## REACTOR COOLANT SYSTEM

### 3.4.4.9 PRESSURE/TEMPERATURE LIMITS

PROPOSED TECHNICAL SPECIFICATION CHANGE - TSP 910005  
VIRGIL C. SUMMER NUCLEAR STATION

DESCRIPTION OF AMENDMENT REQUEST

Figure 3.4-3 V. C. Summer Unit 1 Reactor Coolant System Cooldown (Cooldown rates up to 100°F/hr) Limitations Applicable for the First 14 EFPY (With Margins 10°F and 60 psig For Instrumentation Errors)

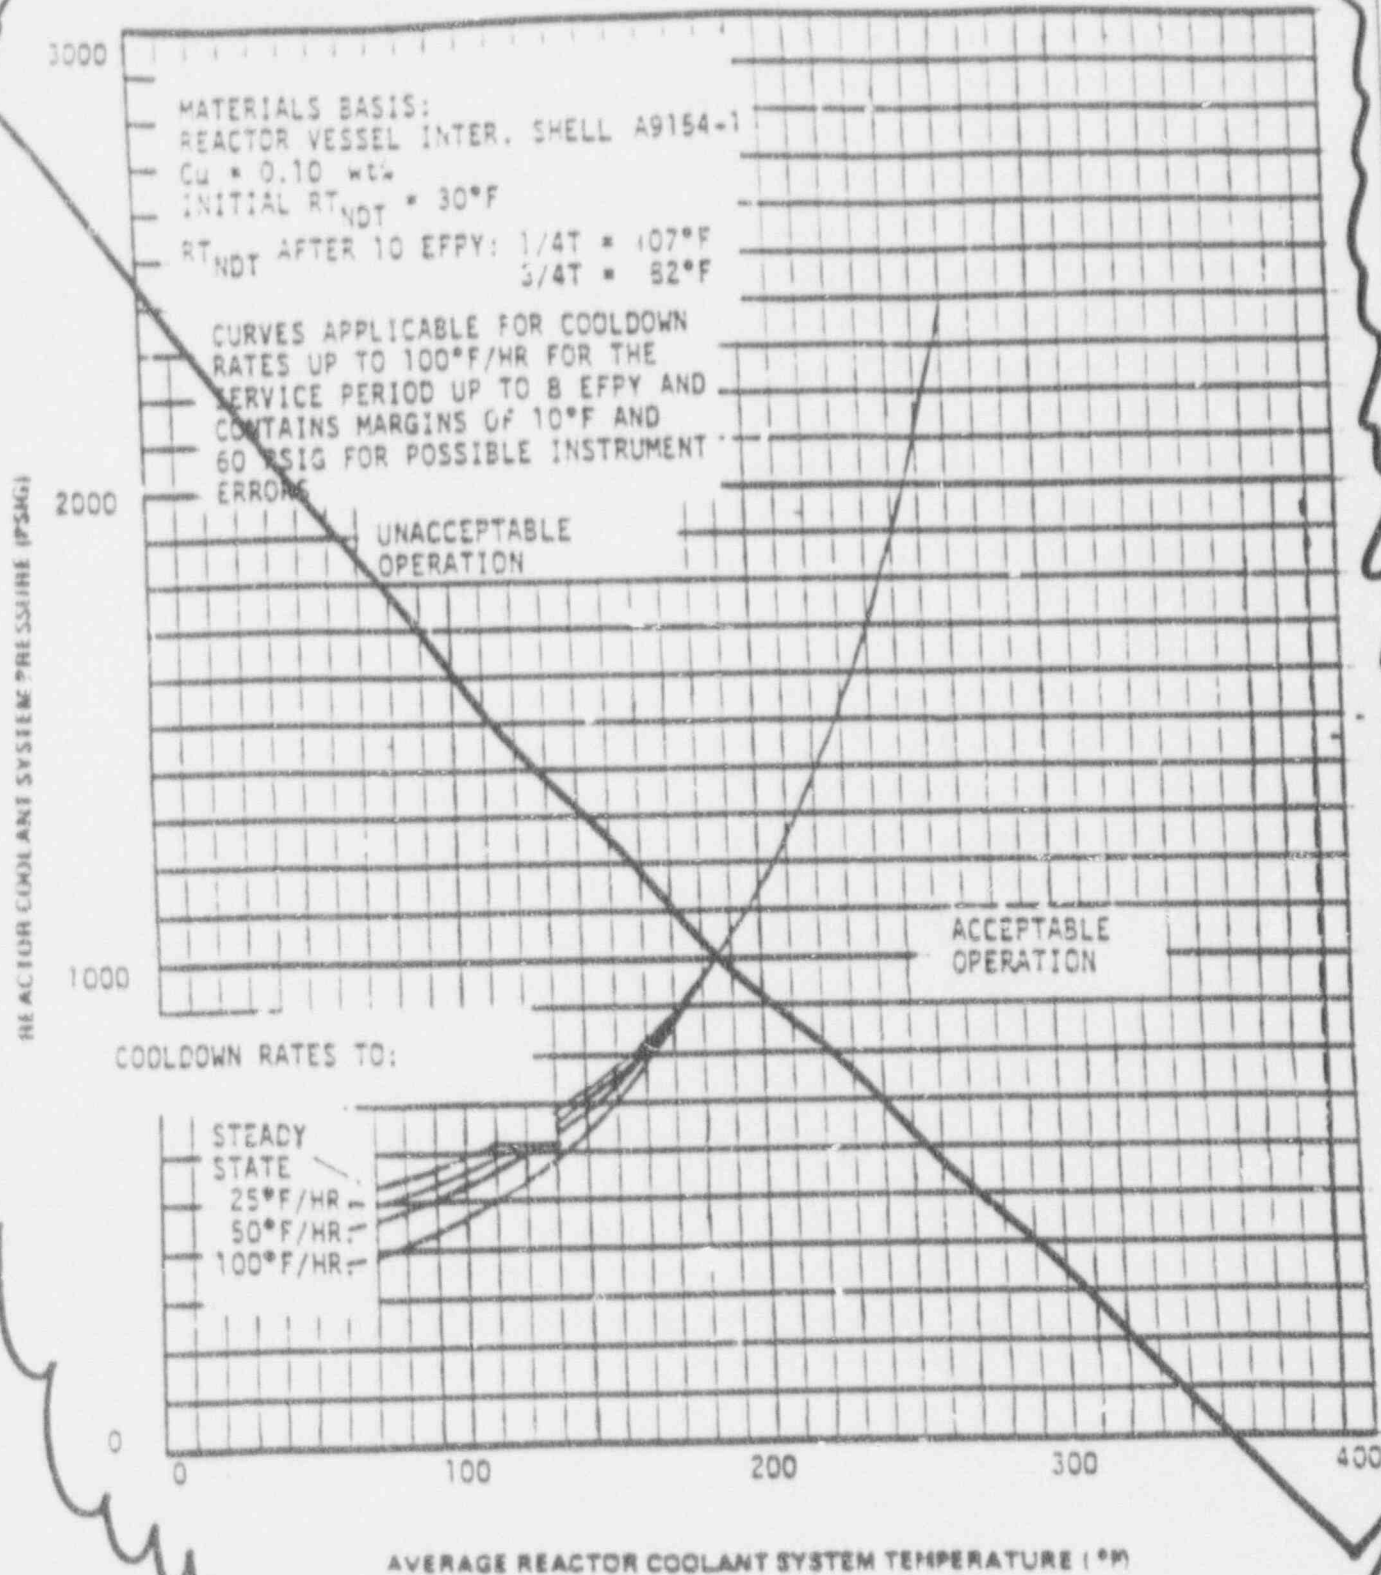
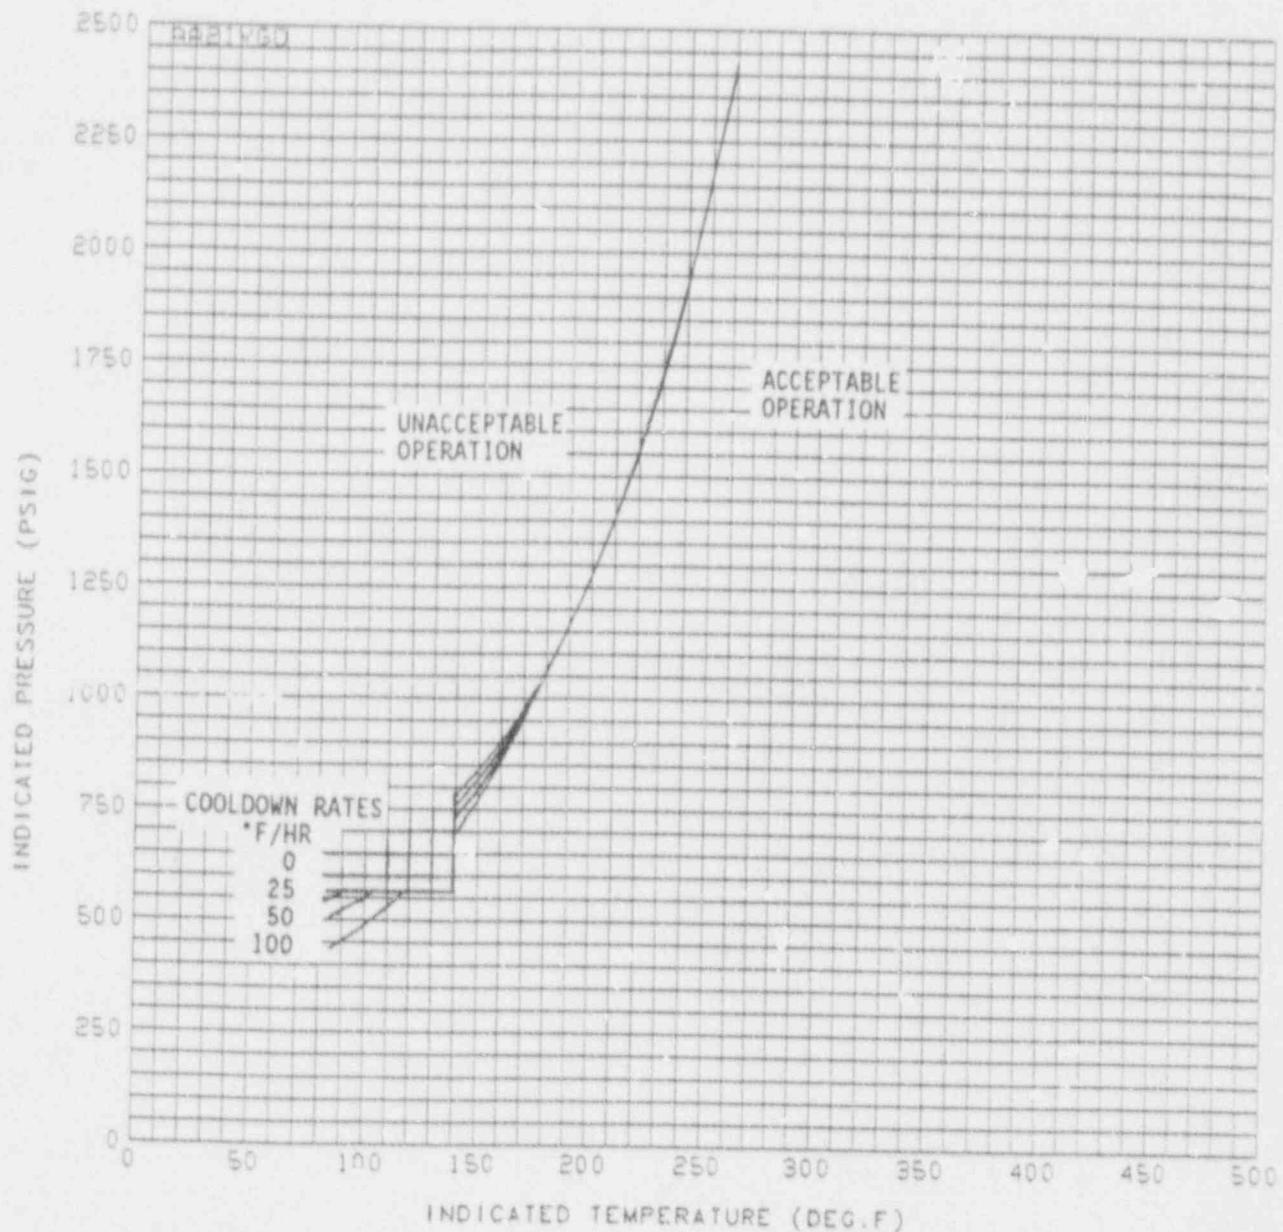
Replace with new curve

SCE&G proposes to modify the VCSNS TS, Section 3/4.4.9, Figures 3.4-2 and 3.4-3, to provide new PT curves consistent with analysis results of examination of specimen X of VCSNS Radiation Surveillance Program. Table 4.4-5 and the reference to it in Surveillance Requirement 4.4.9.1.2 are deleted in agreement with the guidance provided in Generic Letter 91-01.

The proposed change to the PT curves reflect the results of the analysis performed on specimen X, and calculations prepared using the guidance of Regulatory Guide 1.99, Rev. 2, Radiation Embrittlement of Reactor Vessel Materials, and Appendix G to 10CFR50, "Fracture Toughness Requirements."

<u>Page</u>	<u>Specification</u>	<u>Description of Changes</u>
3/4 4-29	4.4.9.1.2	Deleted reference to the Reactor Vessel Material Surveillance Program Withdrawal Schedule
3/4 4-30	Table 4.4.3	Deleted Table 4.4-5 - Page intentionally left blank
3/4 4-31	Figure 3.4-2	Replaced with new curve
3/4 4-32	Figure 3.4-3	Replaced with new curve

Figure 3.4-2 V. C. Summer Unit 1 Reactor Coolant System Heatup Limitations (Heat up rates up to 50 and 100°F/hr) Applicable for the First 14 EFPY (With Margins 10°F and 60 psig For Instrumentation Errors)

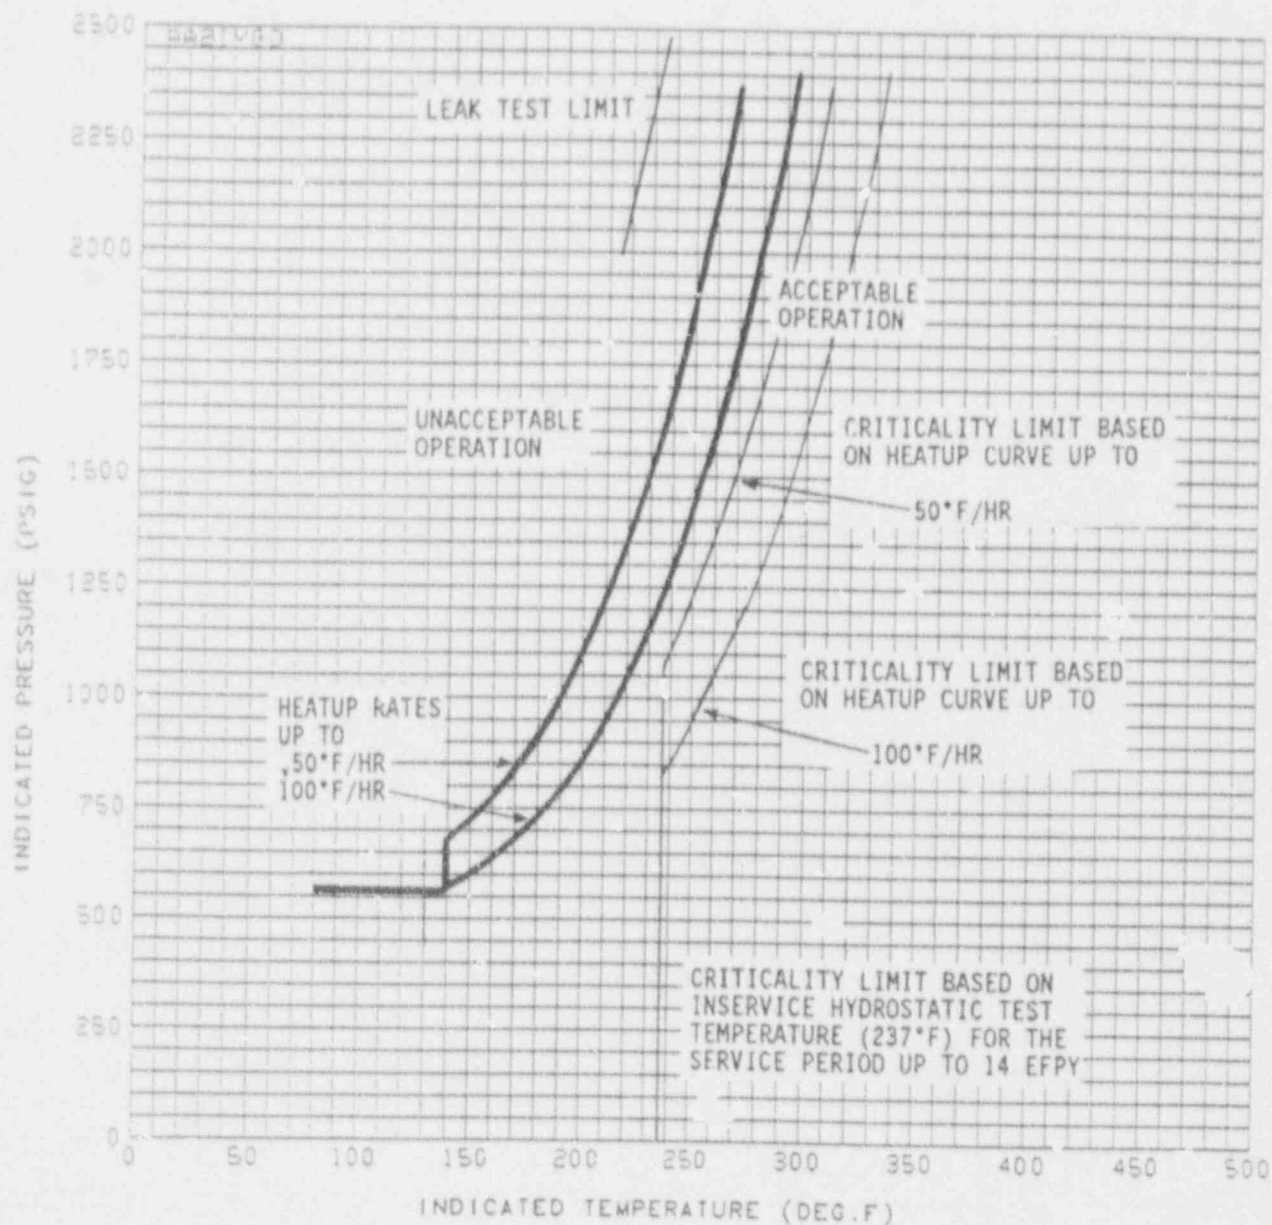
Replace with new curve.
